The Town of Hilton Head Island Special Design Review Board Meeting

DESIGN TEAM/ DRB COMMENT SHEET

PROJECT First Presbyterian Church Addition

DRB# DR100028

FLOOR PLAN (AS CURRENTLY BUILT)

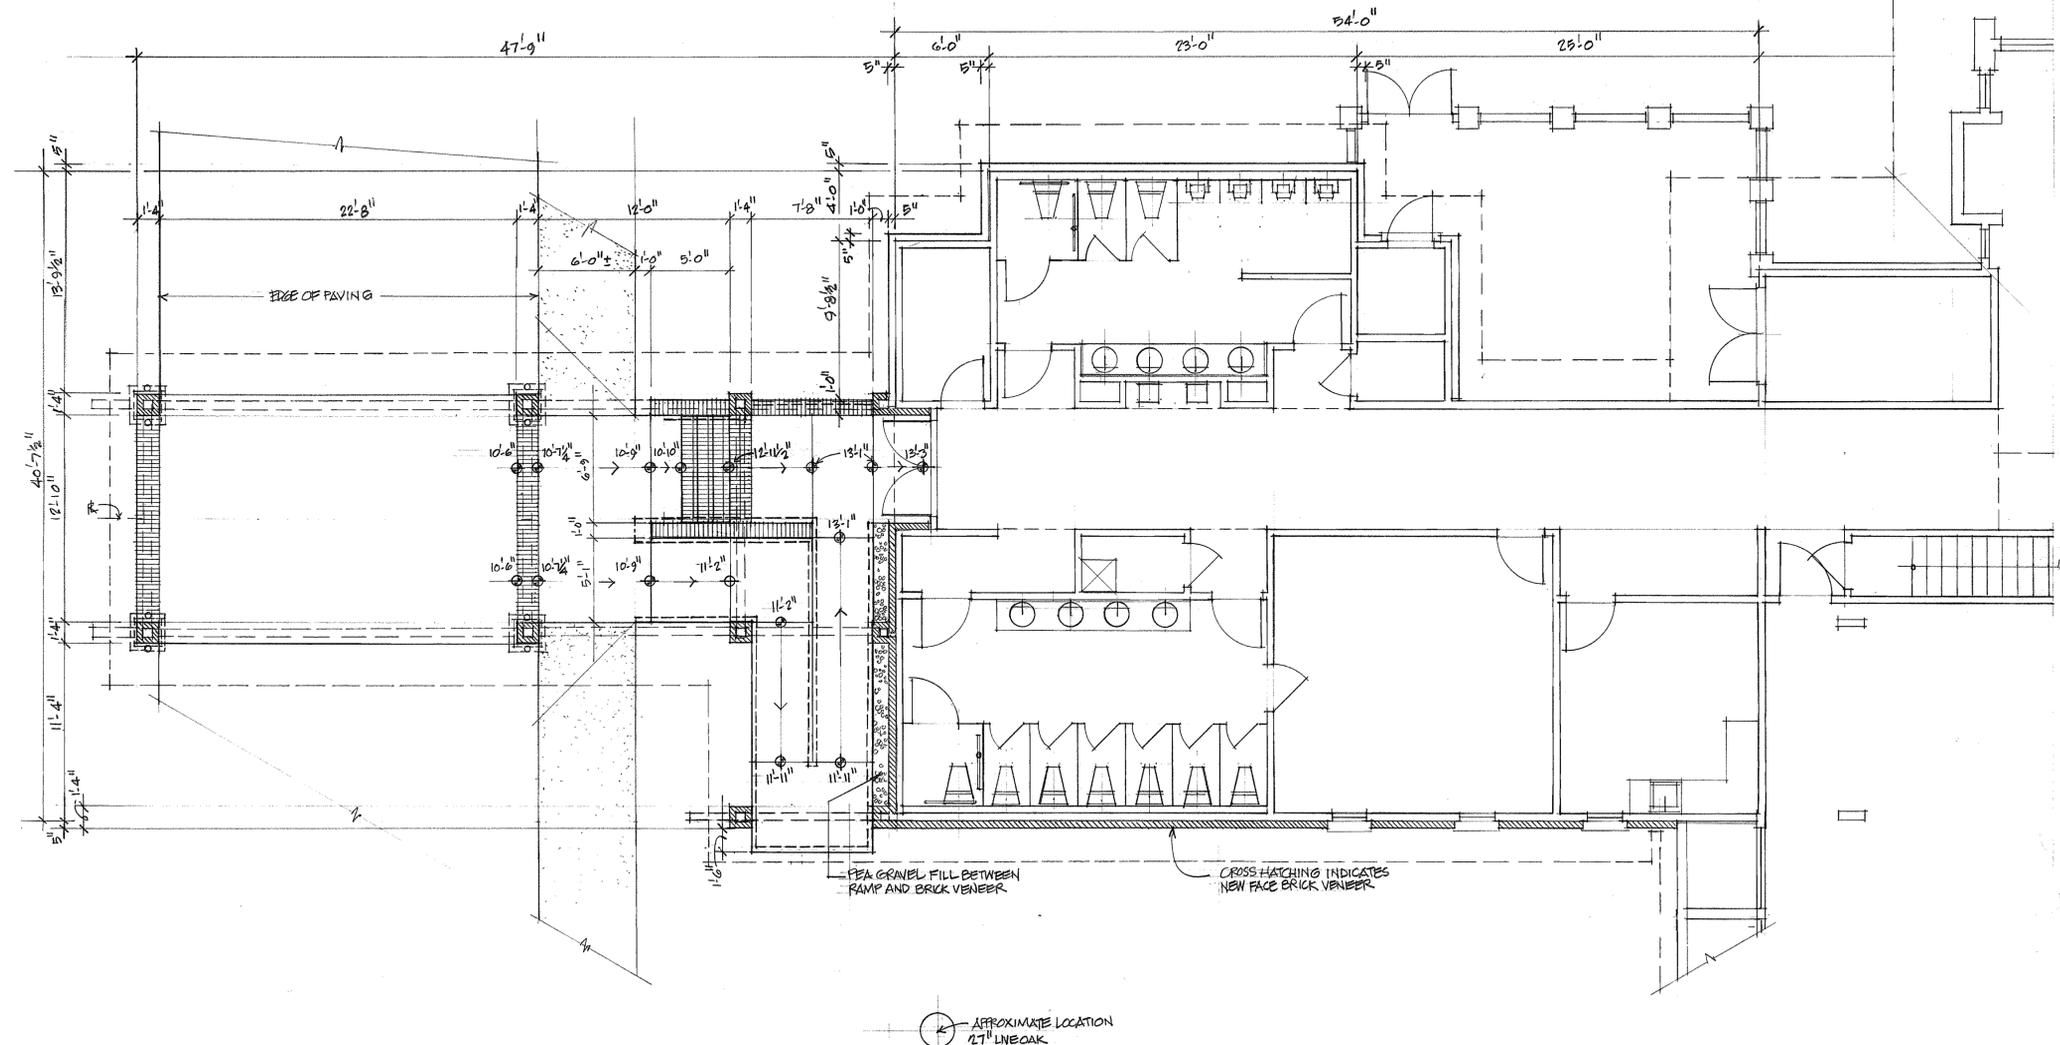
DESIGN GUIDE/LMO CRITERIA	COMPLIES YES/NO/NA	COMMENTS OR CONDITIONS
An effort has been made to preserve existing trees and under story plants		To decrease impacts to root system of 27 inch live oak, remove three RODH nearest tree.
Supplemental and replacement trees meet LMO requirements for size, species and number		
Wetlands if present are avoided and the required buffers are maintained		
Sand dunes if present are not disturbed
